CITY AND COUNTY OF SAN FRANCISCO
DEPARTMENT OF CITY PLANNING

**FINAL
ENVIRONMENTAL IMPACT REPORT**

**PARK HILL
RESIDENTIAL**

PUBLICATION DATE: March 25, 1983
PUBLIC HEARING DATE: April 28, 1983
PUBLIC COMMENT PERIOD: March 25, 1983 through
April 28, 1983
CERTIFICATION DATE: June 30, 1983

FIGURE 7a: West Elevation (Facing Buena Vista Ave. East)

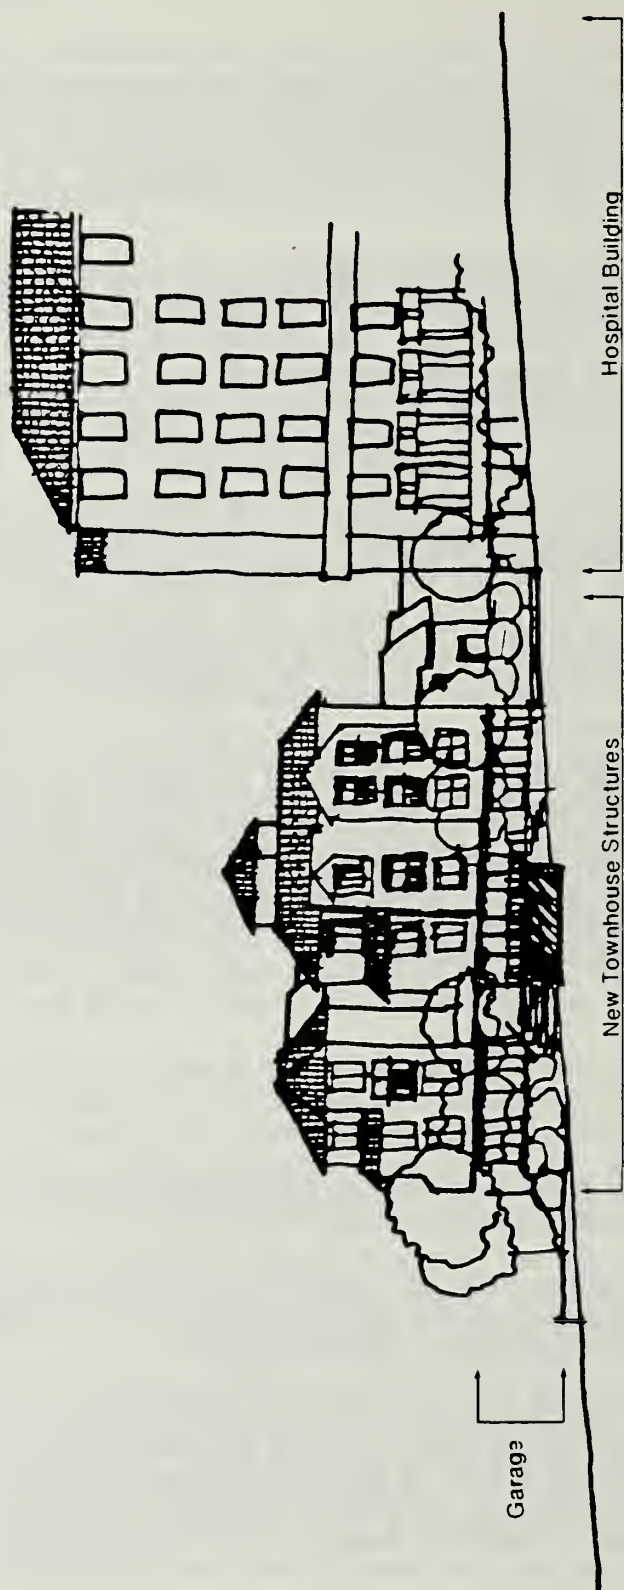
"In this case, there is a conflict. The sponsor realizes that there is a parking garage to be visible at the corner of Park Hill and Buena Vista East, but in the drawing at Figure 7, no parking garage is designed in." (Michael Immel)

Figure 7a has been added to the EIR (see p. 158 of this document). Figure 7a is a sketch of the northern portion of the hospital building and new construction, where the four-story structures are located. The parking garage would be visible at the northwest corner of the site. The garage is not shown in Figure 7 on p. 18 of the Draft EIR because it would not be visible due to landscaping and the eastern viewpoint of the section.

A west elevation which shows the parking garage structure and new construction at the intersection of Park Hill Ave. and Buena Vista Ave. East has been added to the EIR as Figure 7a (see p. 158).

FIGURE 3a: Photograph of Project Model
Looking Southwest

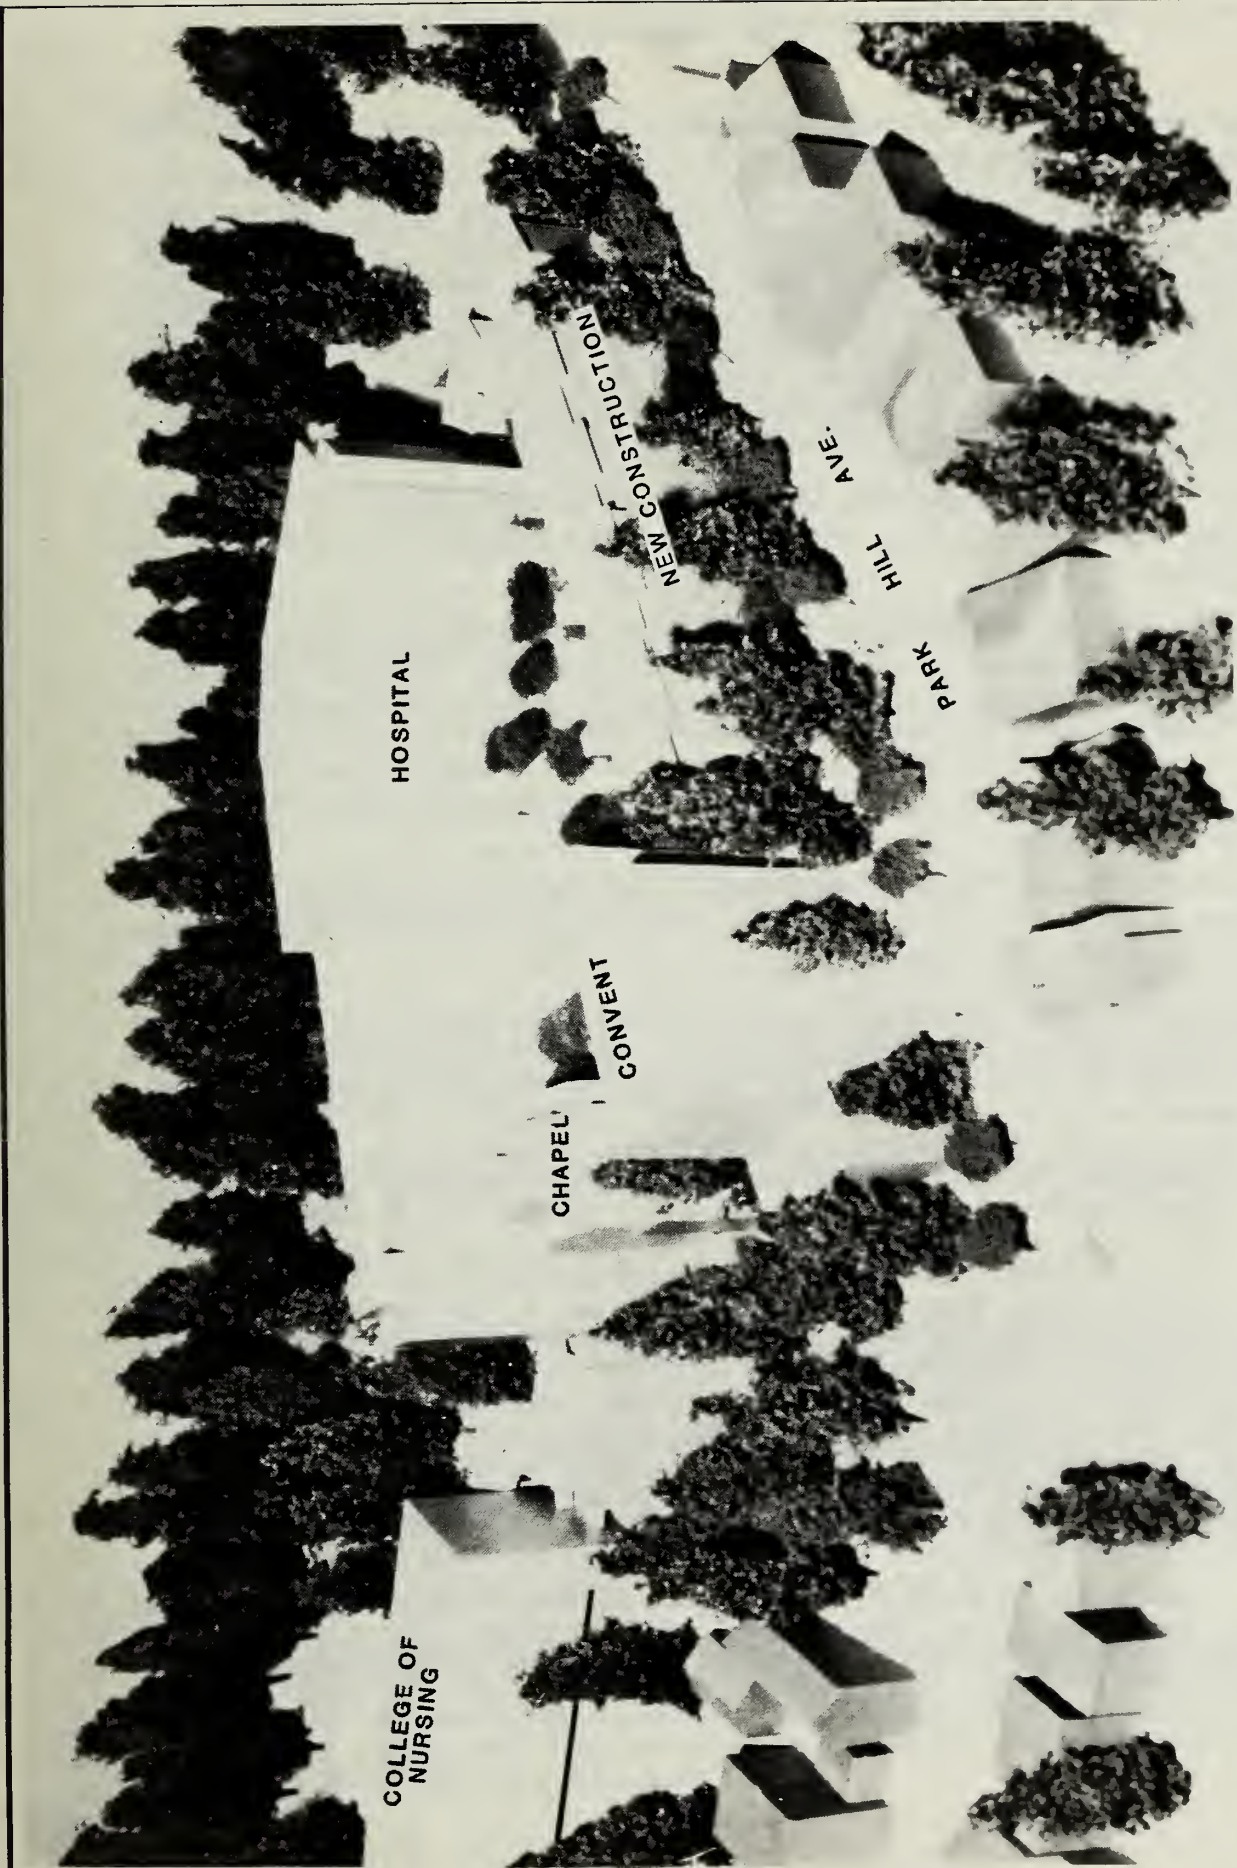
"Proposed extensive landscaping also threatens the existing mature tree masses. New trenches and plants beneath mature trees, and new watering regimes will shorten the life span of the large pine and palm along Park Hill. Existing plantings are not accurately depicted in either Fig. 2 or Fig. 3, pp. 12 and 13 respectively." (CRD, p. 51 and Michael Immel)

In the EIR, Figure 2, p. 12, Site Plan, and Figure 3, p. 13, Photograph of Project Model looking Northwest, are intended to show a conceptual image of tree plantings. The following note has been added to Figure 3:

An additional photograph of the project model has been included as Figure 3a in the EIR (see p. 159); this photograph includes all of the residences on Park Hill Ave. opposite the project site and shows the comparative height and scale of the new construction and the existing residences. Because of the bend in the roadway on Park Hill Ave. and the east-west orientation of the new construction it is not possible to show in a single photograph of the model all of the homes on Park Hill Ave. as well as the upward slope of this street. A view of the model which shows the relative height of the new construction and the existing houses is also constrained because of the inevitable downward angle of a model photograph makes it difficult to perceive topography. Figures 8 and 8a, on pp. 101-102 also show the relative scale of the new construction and the residences on Park Hill Ave.
